PROPOSED REHABILITATION WORKS OF CASTEEL DAM ADDENDUM TO DESIGN REPORT NO. 12/2/X302-26/D/1/30

July 2014

This report is the addendum to the design report that was submitted to Dam Safety Office for issuing of license to construct. The proposed draft report was evaluated according to the dam safety regulations with the following comments to be considered:

Figure 1.1 : Casteel dam flood routing

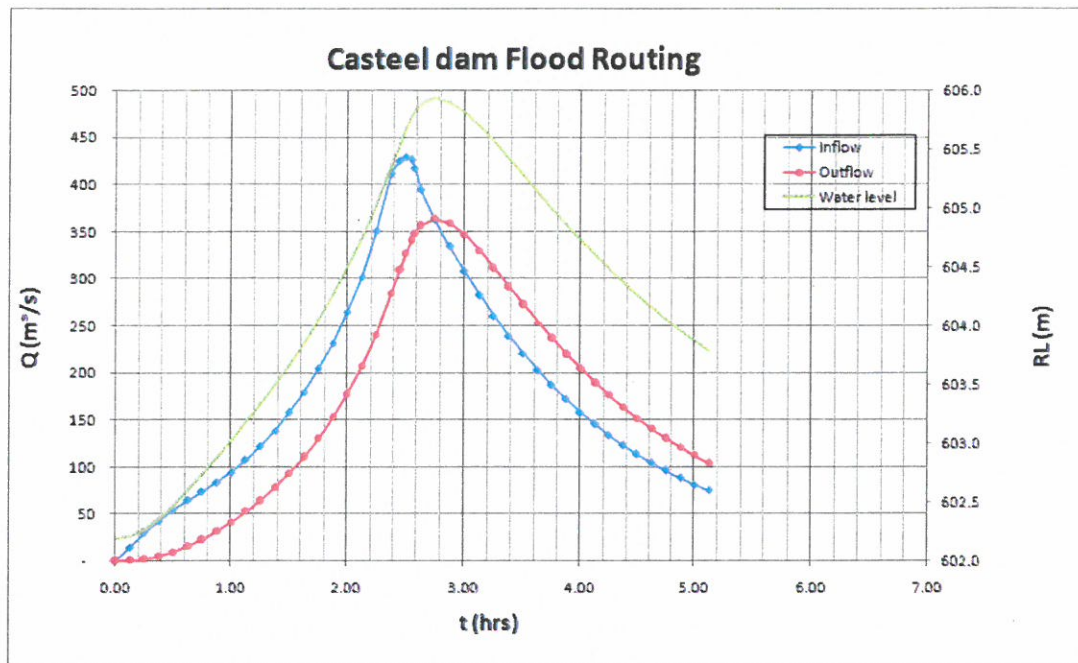
- Coefficient of discharge is taken as 1.93, the value is over estimated.
- Height of the weir is only 1m and during the SEF, the weir will be totally submerged. The weir will not be control point. The spillway channel geometry will be control and for the discharge calculation according to the formulae for by-wash spillway ($Q = 1.705kBH^{1.5}$ for a rectangular shaped concrete structure with square corners $k = 0.82$).

- For this weir the discharge coefficient is about 1.4 which will give maximum discharge capacity of 125 m³/s. If the SEF flood has to pass the spillway, the minimum required freeboard is 4.26 m and embankment has to be raised by 2.4 m at RL 606.4 m and not 605.5 m (section 7.1.2, page 13).

- According to the SANCOLD guideline, the SED use the peak value of RMF without routing. For a more accurate calculation for the spillway, a Hec-Ras analysis is required to perform and determine the spillway discharge capacity, then determine the required increase level for the embankment.

C_d = varies between 1.30 and 1.4 (**Appendix A** model study report of Casteel dam)

Therefore maximum capacity the spillway can handle is 125 m³/s

Using the determined C_d from the model study, the routed RMF overtopped the non overspill crest by 1.94 m. **Figure 1.1** shows flood routing of Casteel Dam. From the model study it was observed that the weir is the control point.

To accommodate the Regional Maximum flood of 430 m³/s, with the current spillway the dam embankment Noc will have be raised with 2 m .

SECTION 01-01
SCALE 1:100

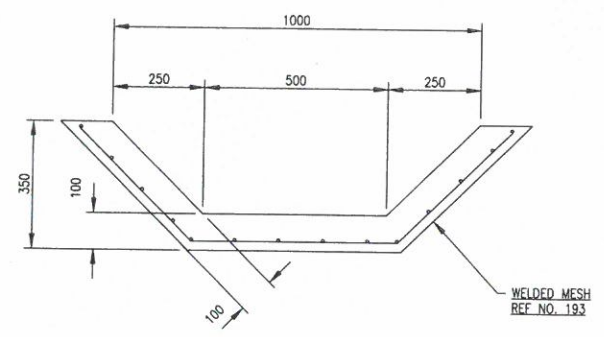
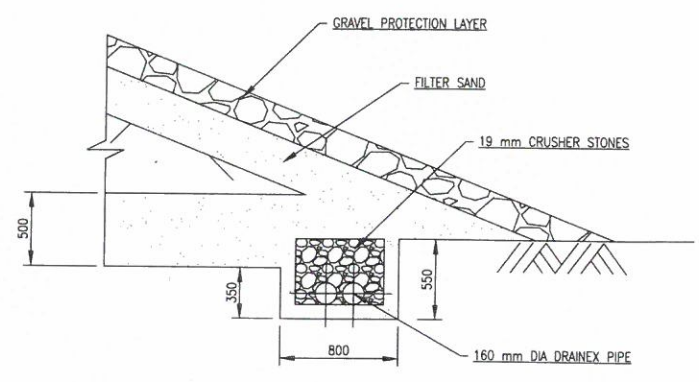
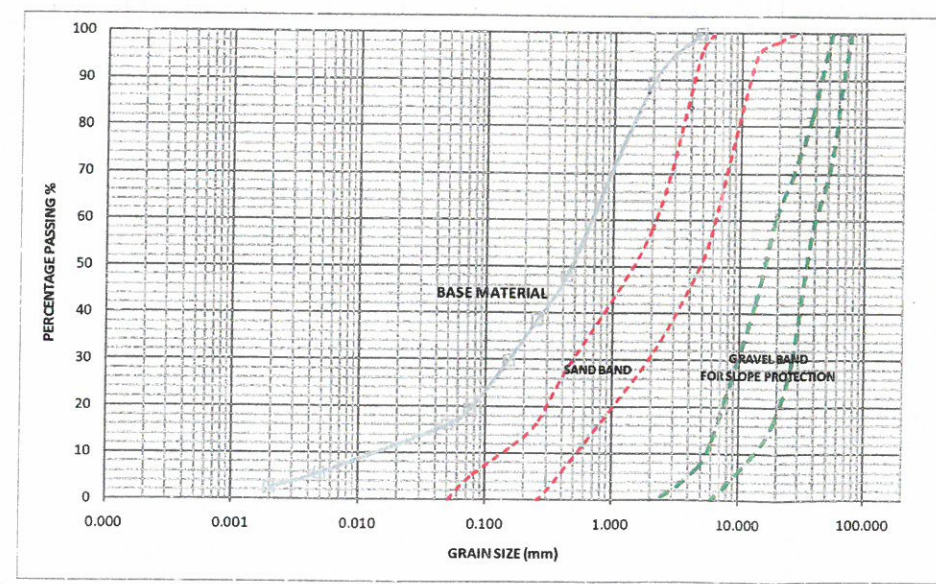
- Chimney and blanket drain layer design 300 mm seem too slim. According to FEMA , filters for embankment dams design criteria that the minimum practical thickness of a drainage blanket is 460 mm suggest to increase to 500 mm for blanket drainage and on the inclined slope filter thickness should be around 1 m.

- Coarse filter does not comply with piping criterion $D_{15}/D_{85} > 5$

An inclined chimney drain of 1m thickness is too much, in practise a 500 mm inclined chimney drain and blanket drain will be sufficient. Both the chimney drain and blanket was revised to thickness of 500mm. To support this decision, most recent rehabilitation project like Mokotswane dam used inclined chimney drain of 400mm. The cost of filter sand will also be a factor. Drawing in **Appendix B** shows the revised chimney drain and blanket drain.

From DSO comments this criterion did not comply because the gravel band D_{15} was checked against base material D_{85} . This gravel band is underlain by sand filter as shown in Drawing in **Appendix B** , therefore D_{85} is of sand filter.
